Hi Noon Ski Club, Thredbo

Development Application Assessment
DA 24/17507

February 2025

Figure 6 | Proposed concrete path location comparison (Source: Applicant's SEE 2024 (left) and 2025 (right))

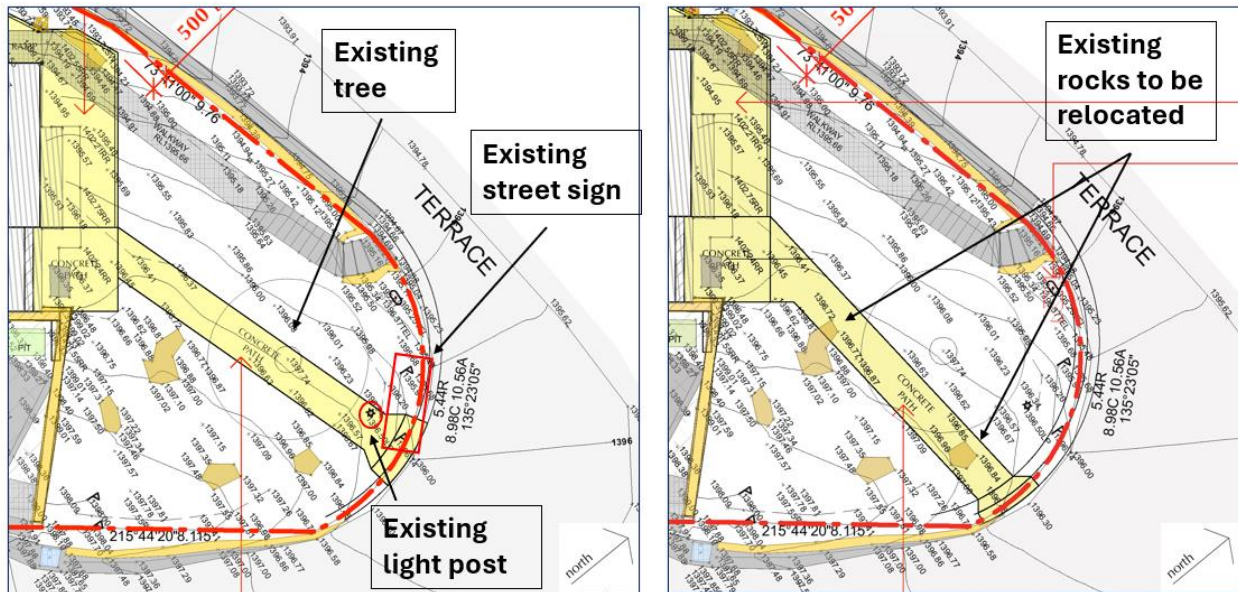
In the Department's Request for Additional Information, concern was raised that the proposed path alignment would impact an existing tree, light post and street sign, and requested the Applicant provide additional details including an Arboricultural Impact Assessment and consent from Kosciuszko Thredbo Pty Ltd for the removal of the sign and light post. The Applicant responded to the Department's concerns, stating that the path would not impact the existing tree, light post and sign and provided revised architectural plans which detail the correct path alignment.

The Department assessed the revised alignment, noting that the path would require the removal of existing rocks in the Hi Noon Ski Club allotment. The Applicant noted that the rocks were placed by Kosciuszko Thredbo Pty Ltd and were not native to the site, and stated that they would be moved to an appropriate area within the lot boundary.
